# Comments on Modal Analysis of the PCal Pylon

LIGO-T1100379-v1

Dennis Coyne

A Finite Element Analysis (FEA) of the Photon Calibrator (PCal) pylon (aka pier) is given in document LIGO-D1101270-v3. In this memo, some approximate calculations of the first resonant frequencies is given for Model 2 of LIGO-D1101270-v3 and compared to the FEA results<sup>1</sup>.

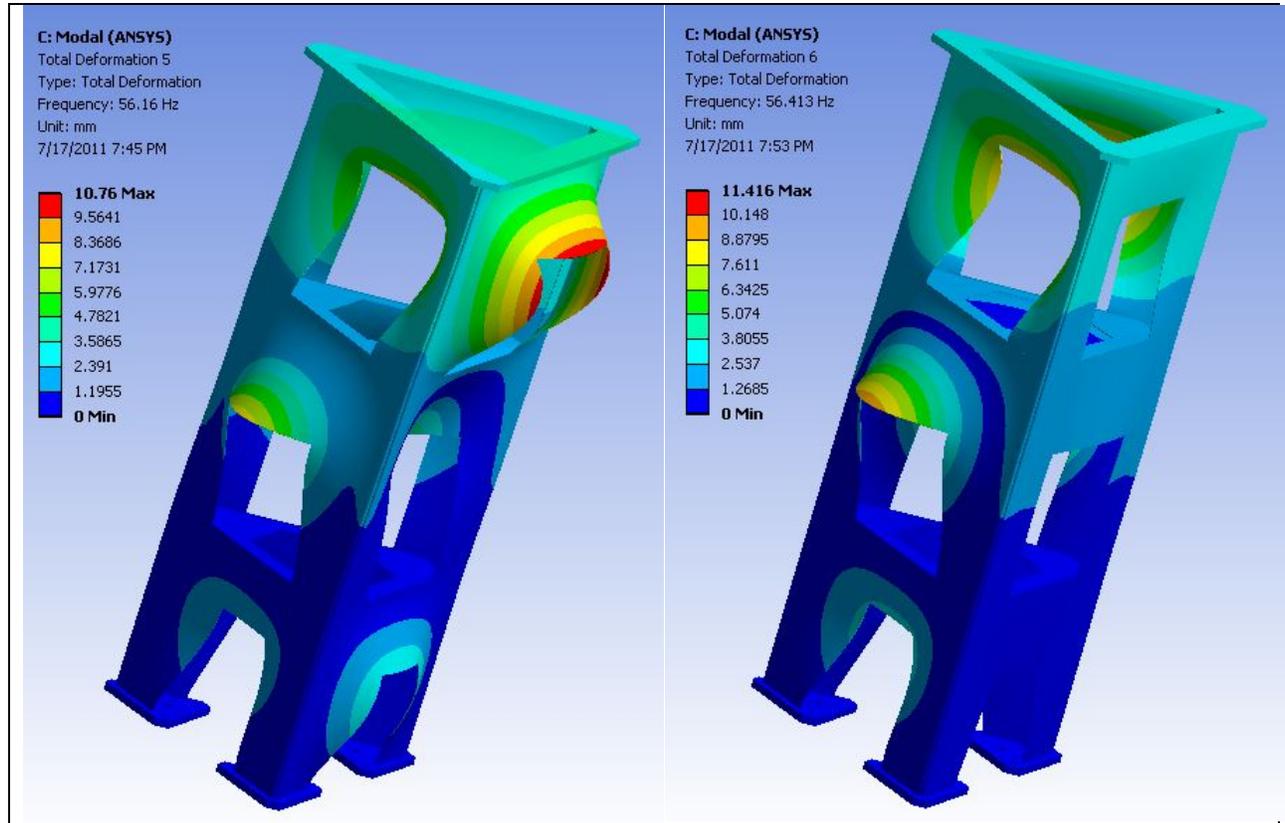
The Pcal Pylon is not a slender beam. However, it is a little beam-like in that it is longer (1.6 m) than it is wide (0.7 m), though not by much. So while we should not expect a simple beam bending frequency to be a close match it may serve to give a very rough approximation to the first beam-like bending mode and give us a rough dependence on the governing parameters. From R.D. Blevins, Formulas for Natural Frequency and Mode Shape, for a cantilevered beam with an end mass (Table 8-8, case 2), the first bending frequency is

where  $E$  = elastic modulus (= 193 GPa for stainless steel),  $I$  is the area moment of inertia of the beam cross-section ( $=1.35 \times 10^{-4} \text{ m}^4$ , determined in the previous section),  $L$  is the beam length (= 1.65 m),  $M$  is the added discrete mass at the end of the beam (= 55.7 kg, the sum of the upper ring mass, 25.7 kg, and the payload mass, 30 kg) and  $M_b$  is the mass of the beam itself (= 40.1 kg, determined with SolidWorks). Consequently,  $f_1 = 81 \text{ Hz}$ .

The corresponding first bending modes from the FEA analysis are modes 5 and 6 at 56 Hz. The beam analysis over estimates the first bending frequency by a factor of 1.45

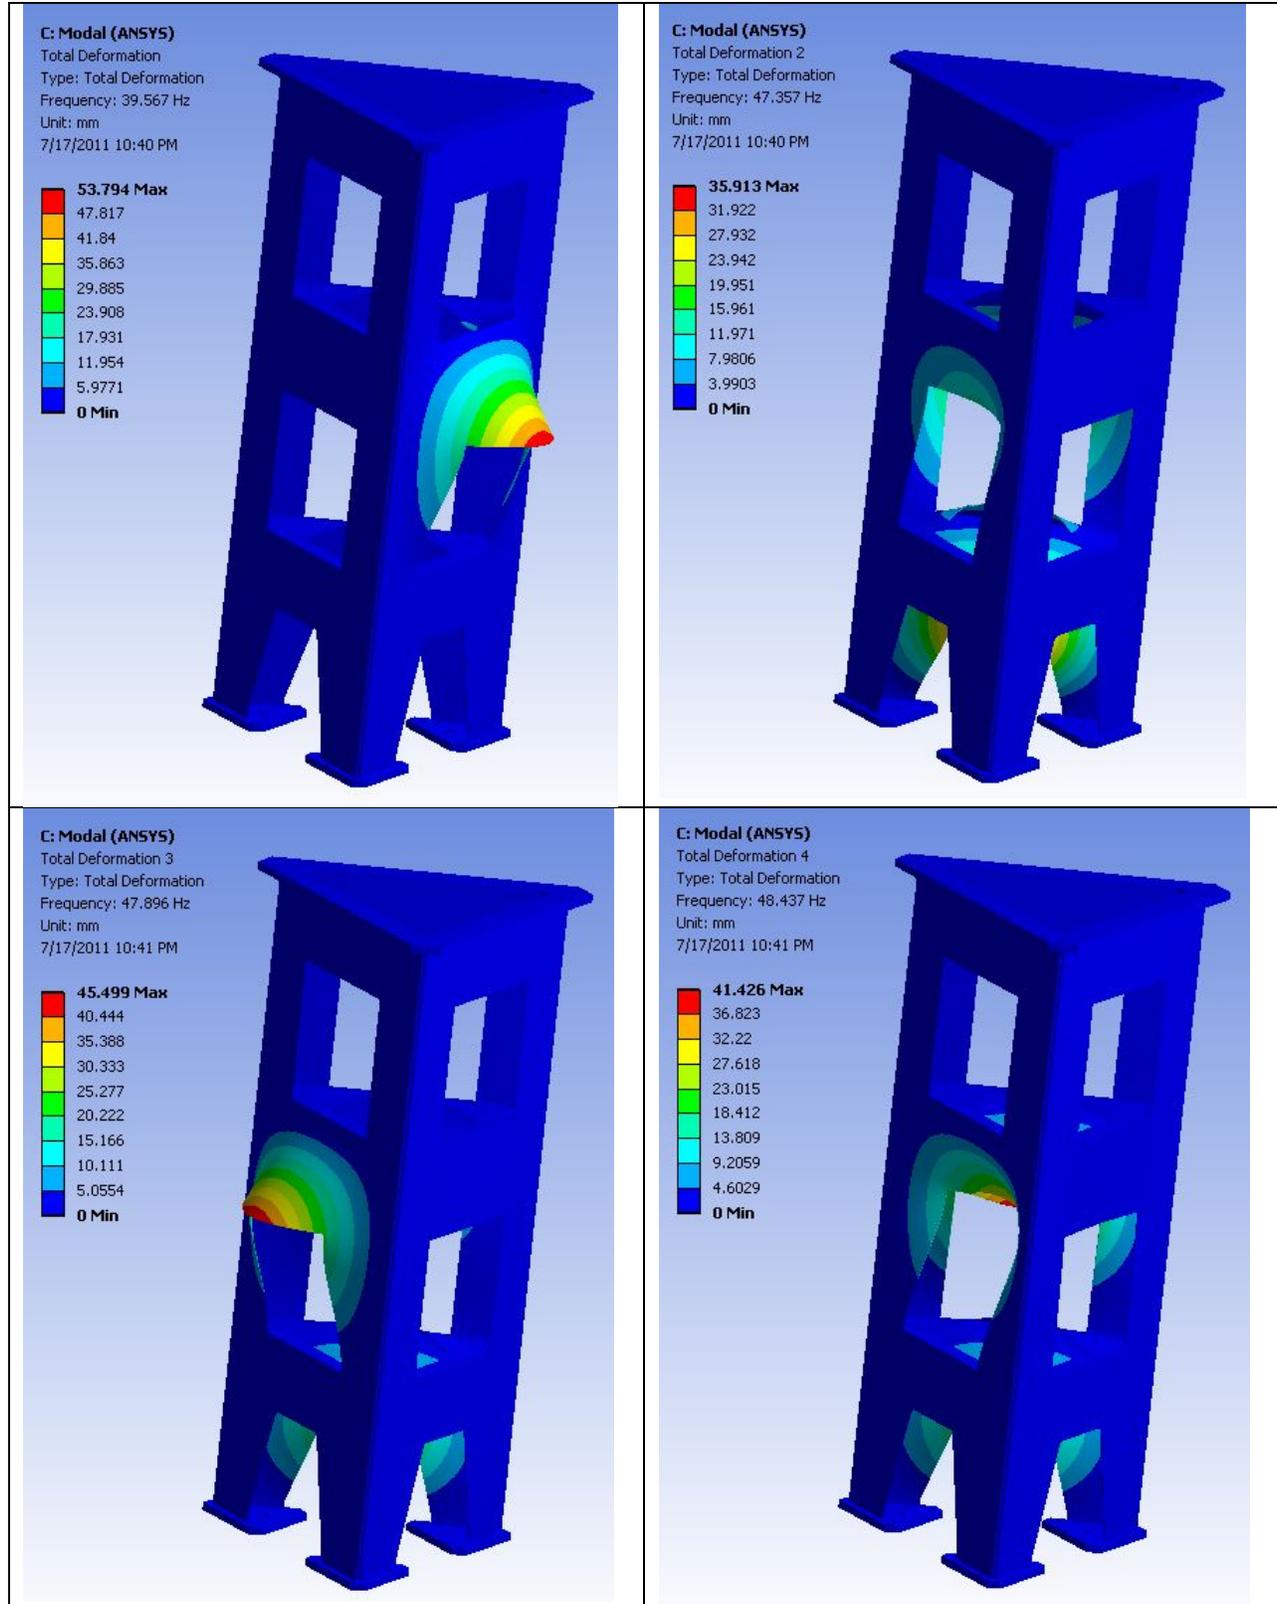
The panels of the PCal pylon can be roughly approximated by rectangular panels which have simple supports on 3 sides and 1 free edge with  $L = 0.24$  m,  $L_y = 0.36$  m,  $\alpha = 1.5$ , as shown in the Figure below.

With simple-free boundary conditions (BC) then  $k_{11} = 14.1$ ,  $D = 120$  Pa and  $f = 49$  Hz.

The first four modes of the FEA calculation are panel modes with frequencies of 40 Hz, 47 Hz, 48 Hz and 48 Hz. I'm not sure why the first frequency is so much lower than the others (it shouldn't be due to symmetry; could be the mesh is not refined enough), but this is relatively good agreement with the approximate analytical calculation.

The low frequency panel modes can be increased by bending the lower edges to change the boundary condition from free to simple. This would increase the first frequency from 49 Hz to ~111 Hz.

To increase the first bending frequencies one could consider increasing the thickness of the stainless steel sheet. Doubling the thickness should increase the first bending frequencies by 31%, so from 56 Hz to ~73 Hz. Doubling the thickness would also increase the panel first resonance to ~200 Hz (if the lower edge is bent over).
